REGULATORY INFORMATION DISTRIBUTION SYSTEM (RIDS)

SUBJECT: Forwards marked-up pages originally submitted in response to
 NRC Questions 031,139,031.140 & 031.141, closing out SER
 Outstanding Issue 10 re standby svc water instrumentation &
 control design.

Subject: NUCLEAR PROJECT NO. 2
CLOSURE OF OUTSTANDING ISSUE
NO. 10, NUREG-0892, WNP-2 SER

Q. 031.139

TABLE 031.139-1

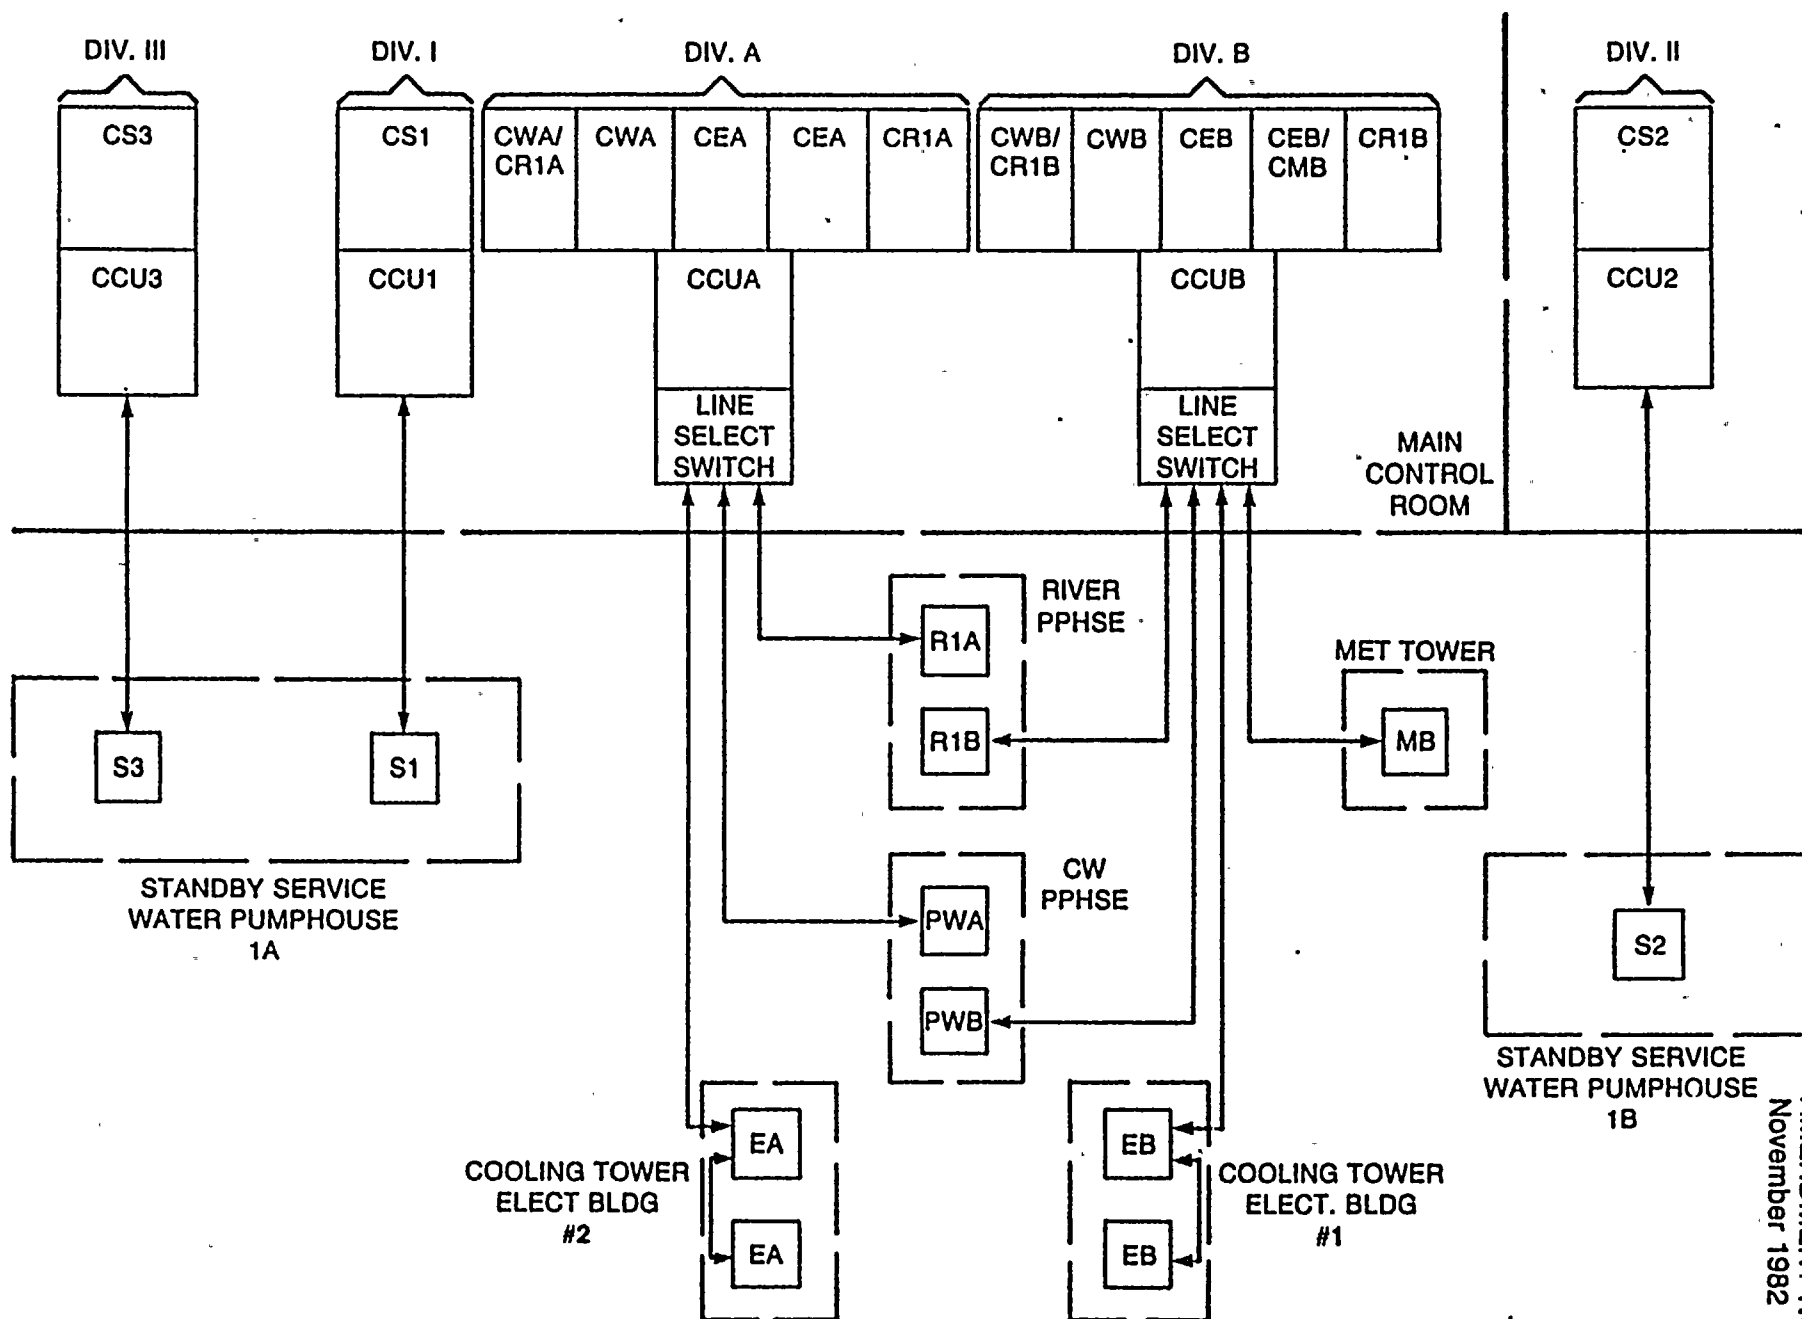
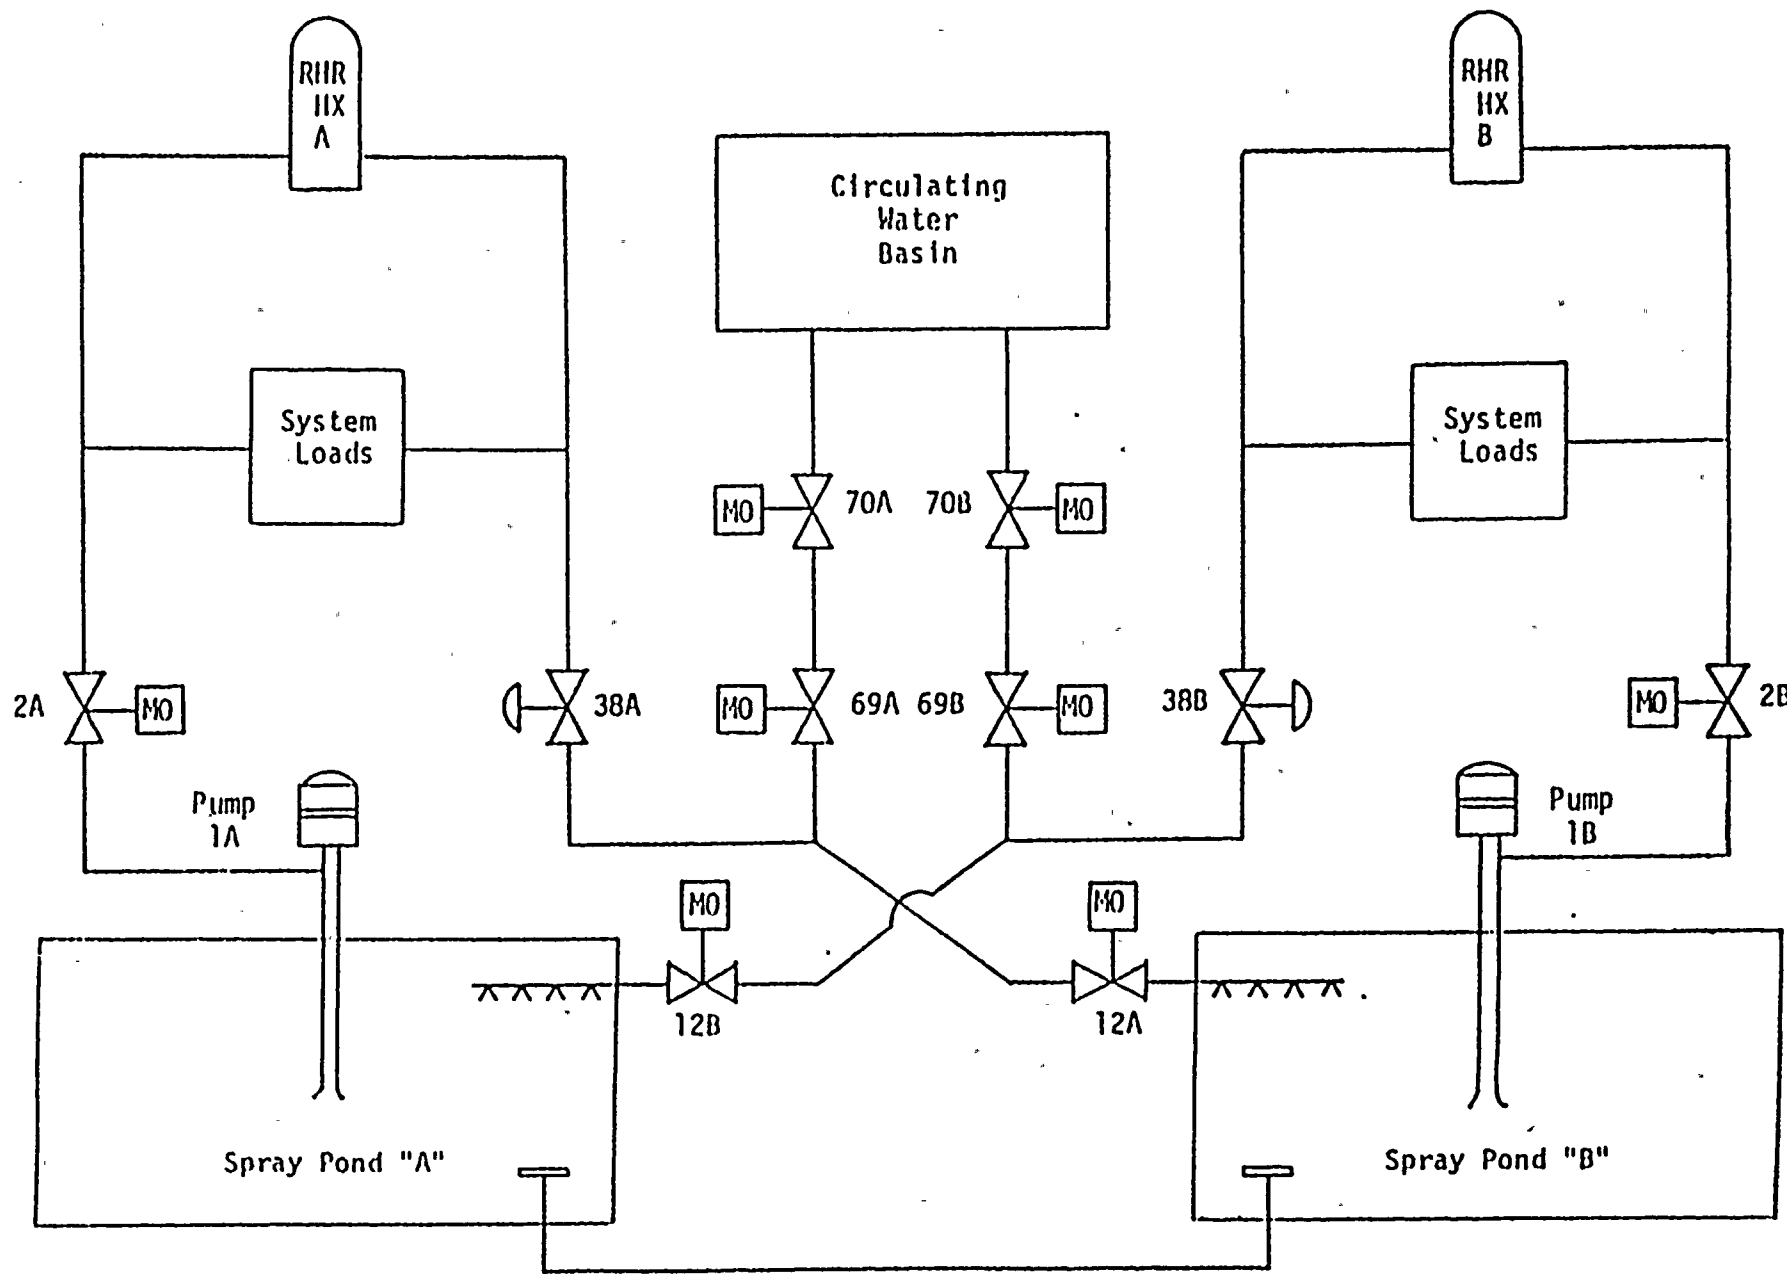
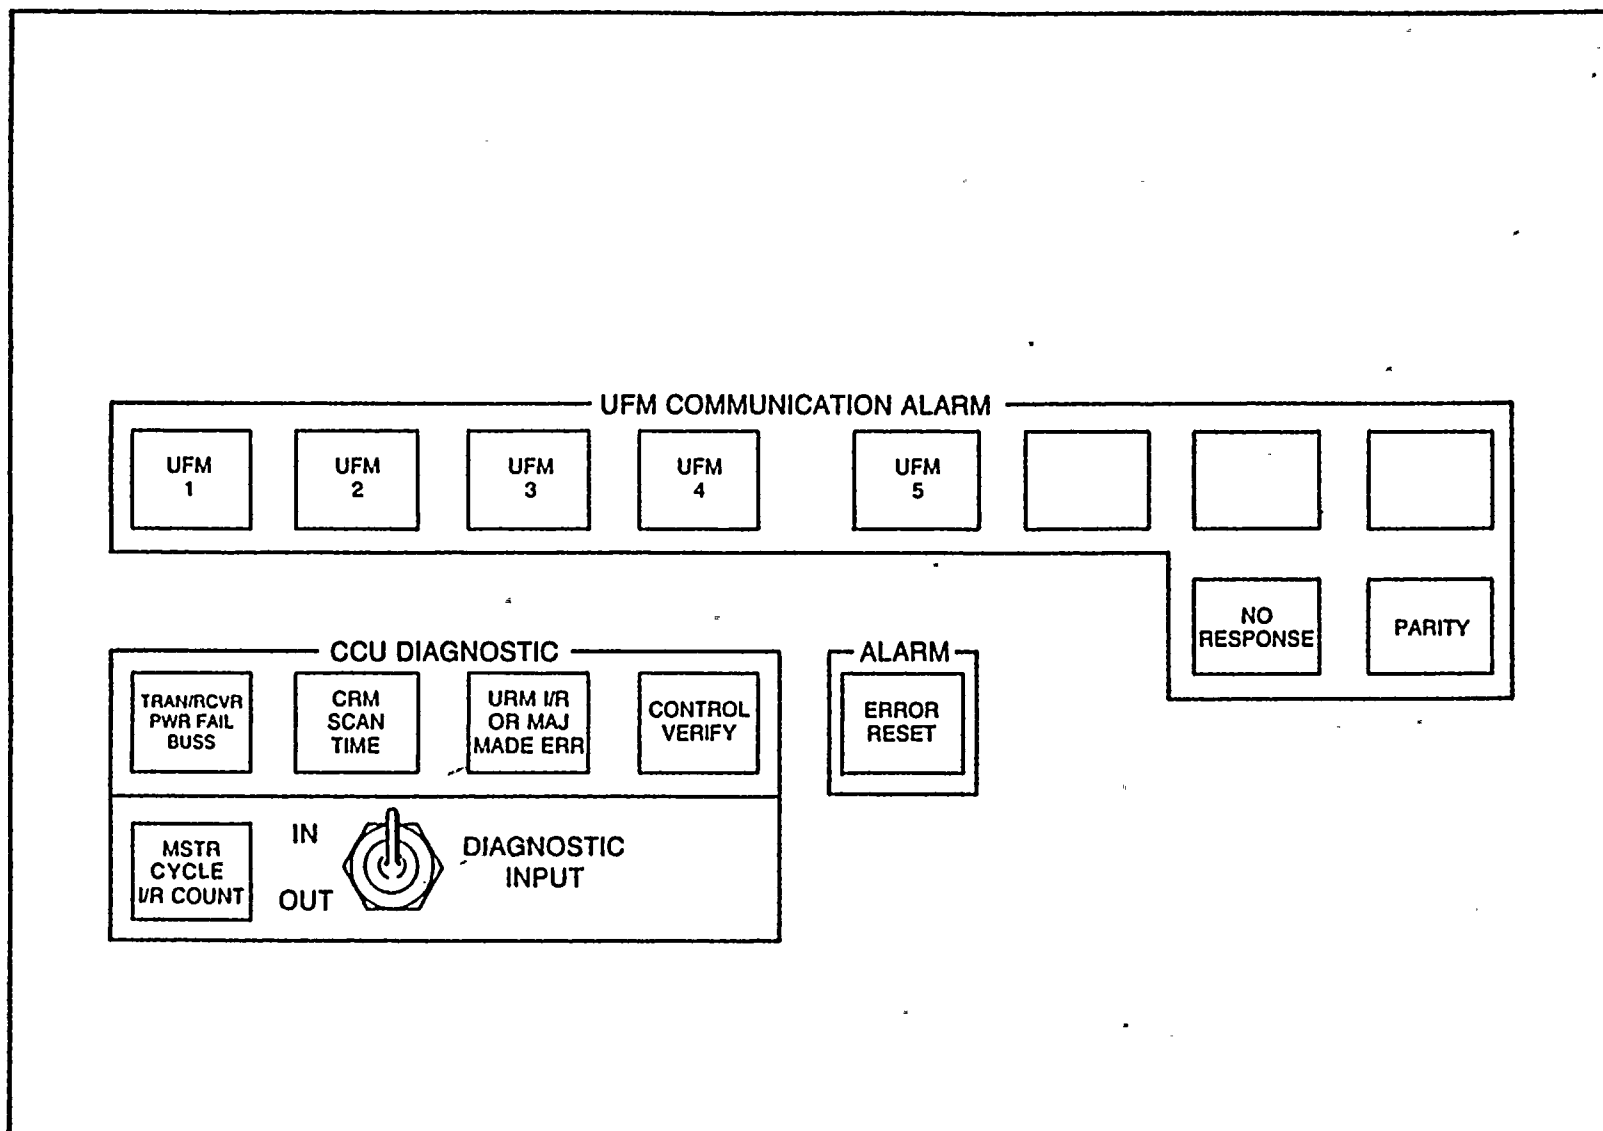
- f. Confirmation based on review of equipment elementary electrical diagrams that failures of the multiplexer system will not, itself, cause standby service water (SSW) equipment to change state, while SSW is in the standby mode, such that SSW equipment is damaged.

The only components which change state as a result of multiplexer system failures are the pump motor heater and loop pressure control valve SW-PCV-38A.

Table 031.139-1 presents the unit point functions of various multiplexer channels by component in the standby service system.

FIGURE
031.139-4d

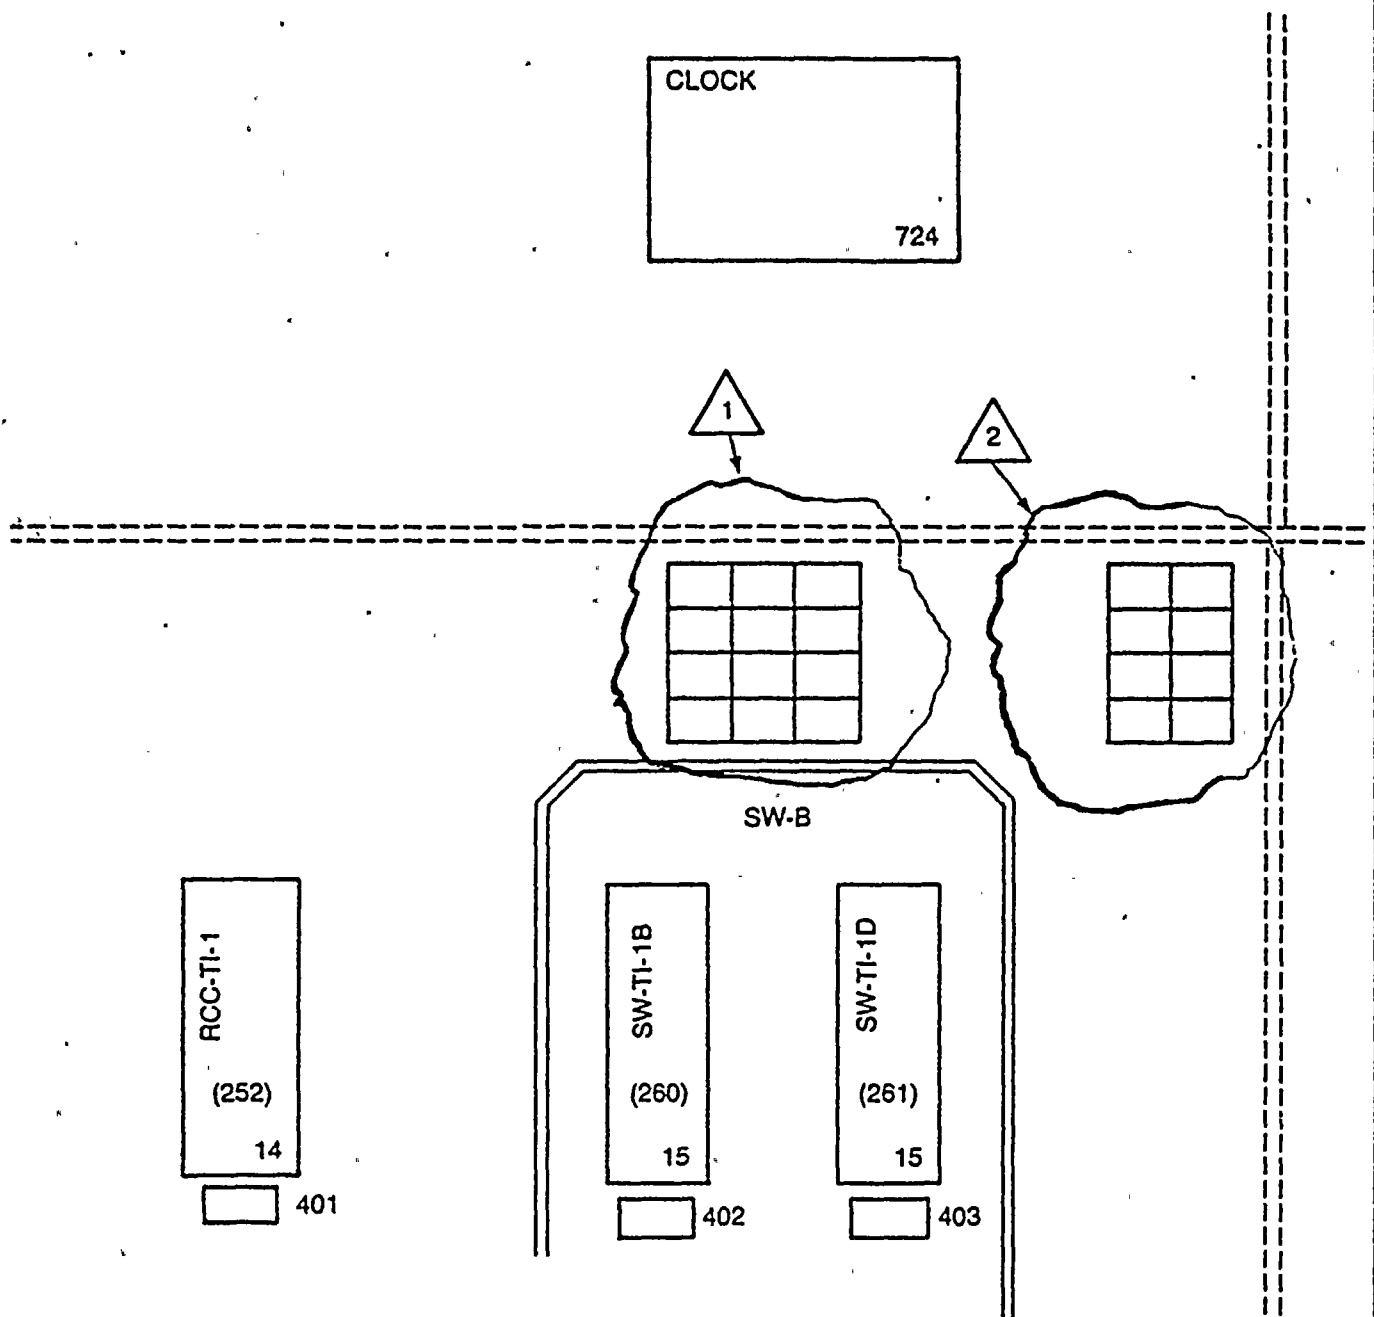
*Annunciators at Board P in Main Control Room:

Drop # P1-6.3	"STDBY SERVICE WTR PPHSE 1A SUPV SYSTEM DIV. I TROUBLE"
Drop # P2-6.2	"STDBY SERVICE WTR PPHSE 1B SUPV SYSTEM DIV. II TROUBLE"
Drop # P1-8.4	"STDBY SERVICE WTR PPHSE 1A SUPV SYSTEM DIV. III TROUBLE"

A commitment was made by the Supply System to confirm that these alarms are indicated to the operator consistent with Regulatory Guide 1.47 (see Part d of this response).
